**PLANNING CLEARANCE**  
(Single Family Residential and Accessory Structures)  
Grand Junction Community Development Department

BLDG ADDRESS 2367 RAMA Rd. TAX SCHEDULE NO. 2945-174-30-062  
SUBDIVISION The Ridges SQ. FT. OF PROPOSED BLDG(S)/ADDITION 1158  
FILING 6 BLK 13 LOT 62A SQ. FT. OF EXISTING BLDG(S) None  
(1) OWNER BOOKCLIFF BUILDERS LTD. NO. OF DWELLING UNITS  
BEFORE: 0 AFTER: 1 THIS CONSTRUCTION  
(1) ADDRESS 316 Cedar St. 81503 NO. OF BLDGS ON PARCEL  
(1) TELEPHONE 242-2212 BEFORE: 0 AFTER: 1 THIS CONSTRUCTION  
(2) APPLICANT BOOKCLIFF BUILDERS LTD USE OF EXISTING BLDGS None  
(2) ADDRESS SAME DESCRIPTION OF WORK AND INTENDED USE: \_\_\_\_\_  
(2) TELEPHONE \_\_\_\_\_ New Single Family Residence

Van Der Werff Residence

<b>Site Plan</b>	Approvals:			
	Scale: NONE			1158 sq ft

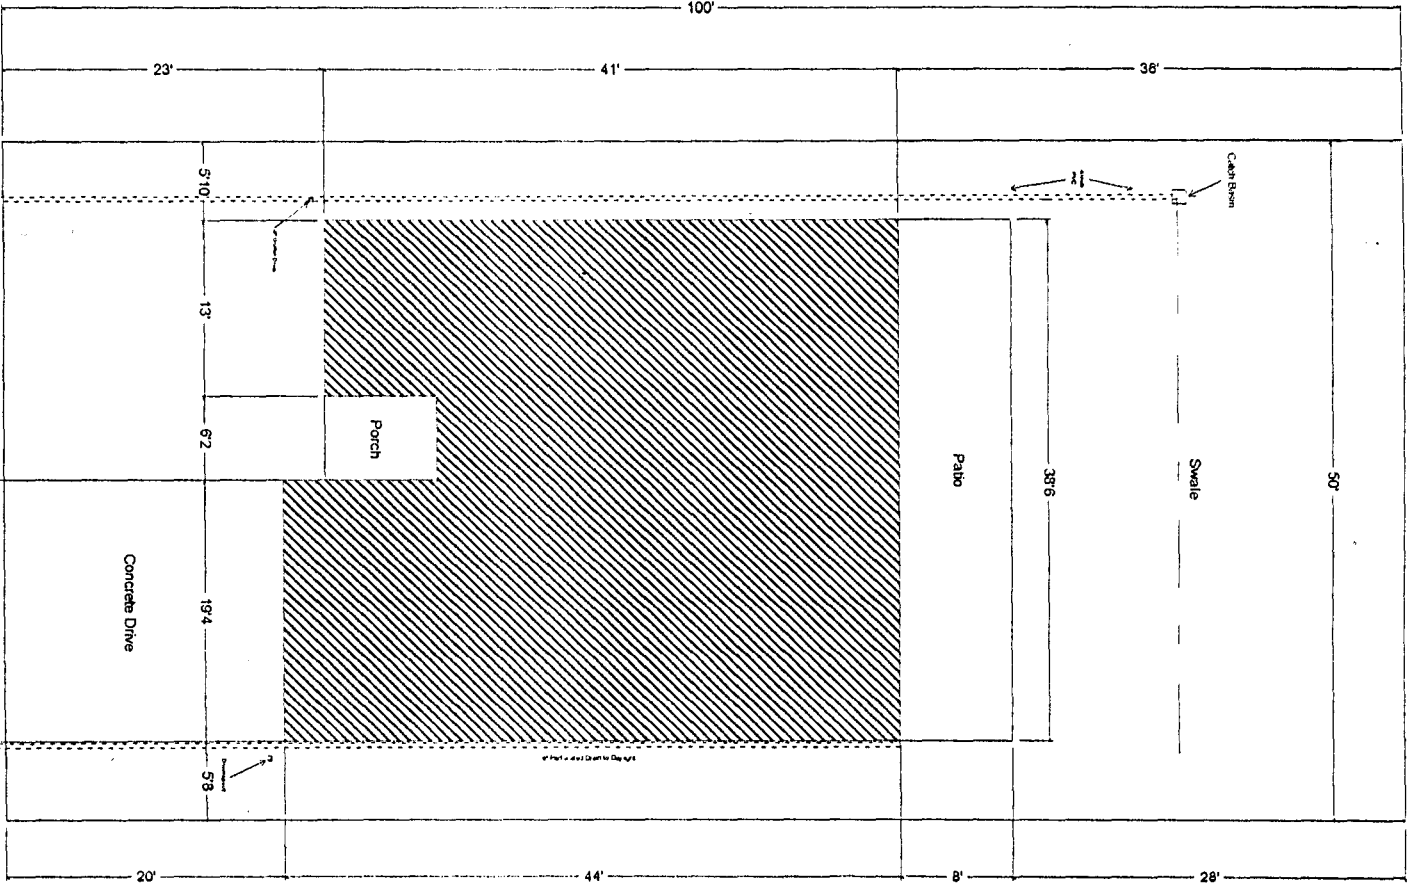
**ACCEPTED** *SLC 6-23-97*  
 ANY CHANGE OF SETBACKS MUST BE APPROVED BY THE CITY PLANNING DEPT. IT IS THE APPLICANT'S RESPONSIBILITY TO PROPERLY LOCATE AND IDENTIFY EASEMENTS AND PROPERTY LINES.

*DRIVEWAY LOCATION OK.  
 Klotzbeck 6/16/97*

**Site Plan**

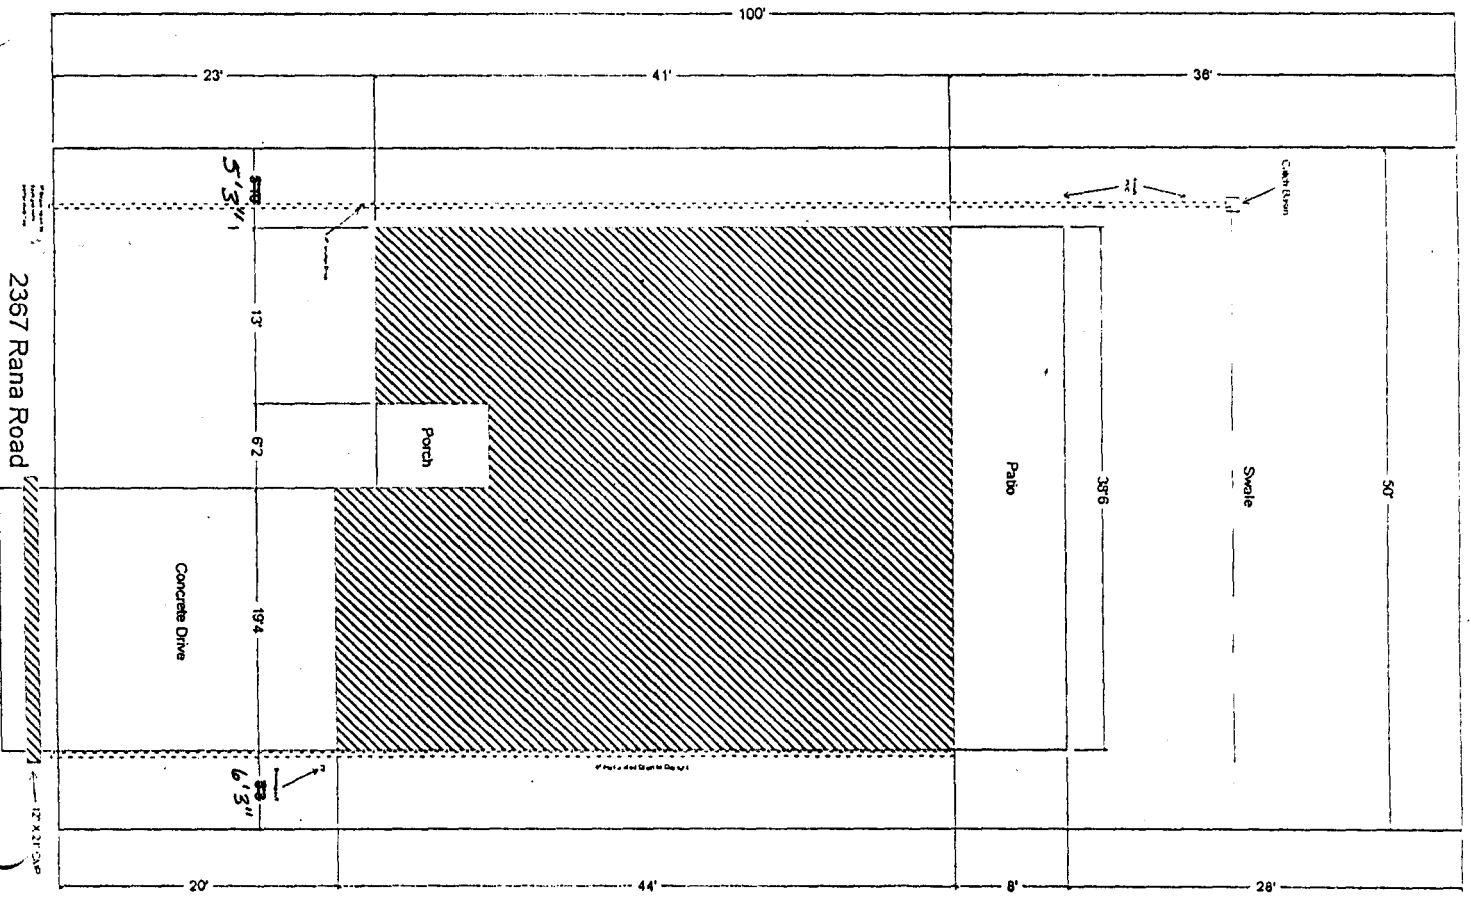
**REVISED**  
**ACCEPTED SLI 6/25/97**  
 ANY CHANGE OF SETBACKS MUST BE APPROVED BY THE CITY PLANNING DEPT. IT IS THE APPLICANT'S RESPONSIBILITY TO PROPERLY LOCATE AND IDENTIFY EASEMENTS AND PROPERTY LINES.

DRIVEWAY LOCATION O.K.  
 setback 6/16/97
